PGL File #: 3705-06.01

DATE: April 16, 2018

**RE: BRAGG CREEK FLOOD MITIGATION PROJECT: POTENTIAL PATHWAYS OF EFFECT ON  
DOWNSTREAM LANDS AND WATERS**

Figure 2: After Application Appendix B, Figure 6.4 showing predicted 1:100-year flood water levels with training structure upstream. White oval indicates a narrow reach before the Elbow River widens to the braided floodplain where flooding is likely.

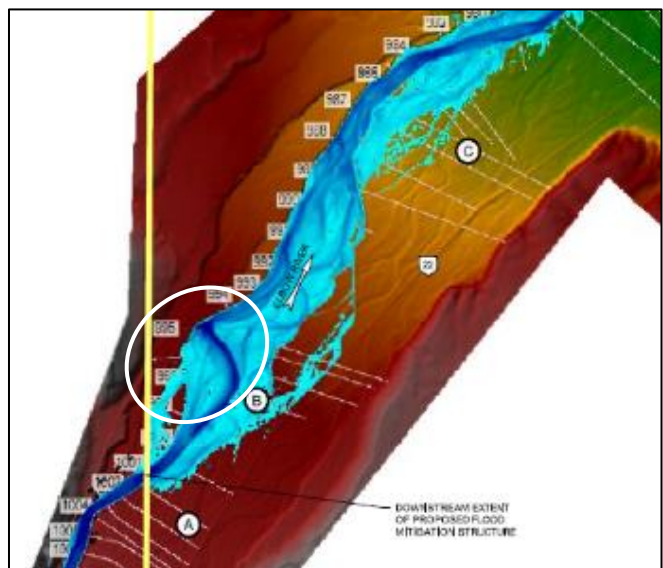
Appendix B, Figure 6.4 (reproduced in part, at right) demonstrates that this does, in fact, occur under a 1:100-year flood scenario. While the model predicts that the Project should reduce the level of flooding over the no-project scenario in certain locations, flooding will still occur in other locations. Given the increased water velocities predicted to result downstream as a result of the Project it is reasonable to expect that more and/or larger debris may be carried through the project reach to be deposited downstream of the project on Tsuut’ina or other lands. The distance this material may be carried has not been modelled.

The Application notes that downstream effects are unlikely, because “the channel downstream of the Hamlet boundary is wide and braided...[and] As such...is expected to have limited impacts on the current channel morphology of this reach.”

This statement is inaccurate. As indicated in Application Appendix C, Figure 6.4 (reproduced at left), the 1924 bank line (in blue) shows a braided river downstream of the Township/Reserve boundary; the 2012 (green) and 2013 (red) bank lines show a substantially narrower bank that, if unprotected, could reasonably be expected to be the site of a bank breach and subsequent flood onto Tsuut’ina land.

Figure 3: From "Government of Alberta, 2009. Prepared by the ASRD, South Rockies, Resources Information Unit-Calgary). Elbow River Alluvial Aquifer shown in pink.

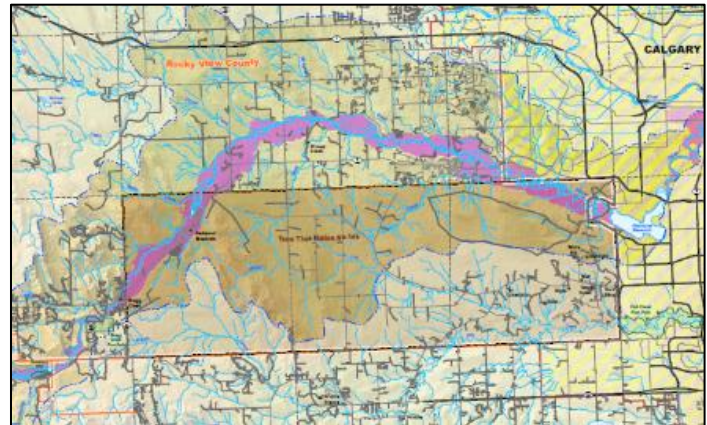
The aquifer is identified in pink in Figure 3, to the right.

Over time, the faster flowing water through the project infrastructure may promote downstream changes. Specifically, the Project may foster a narrower, faster river downstream of the infrastructure, with consequent effects on the aquifer.

Figure 4: From: Tsuut'ina Nation Water Needs Assessment, Dillon Consulting for Tsuut'ina First Nation, 2009, excerpt from Figure 5.7. Colour represents well yield in gallons/minute; lighter colour are lower producing wells. Effects of the Project on these wells has not been assessed.

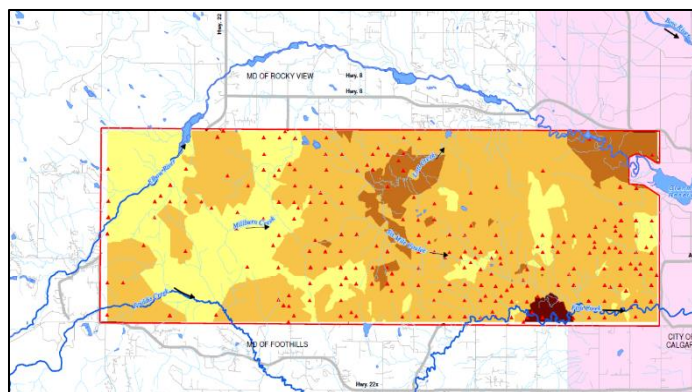
These effects may be felt as far downstream as the downstream limit of the aquifer (to the Glenmore Reservoir); that development has been encroaching on the natural flood plain for the past century suggests that these effects may already have begun and that this Project will exacerbate long-term effects to downstream water users.
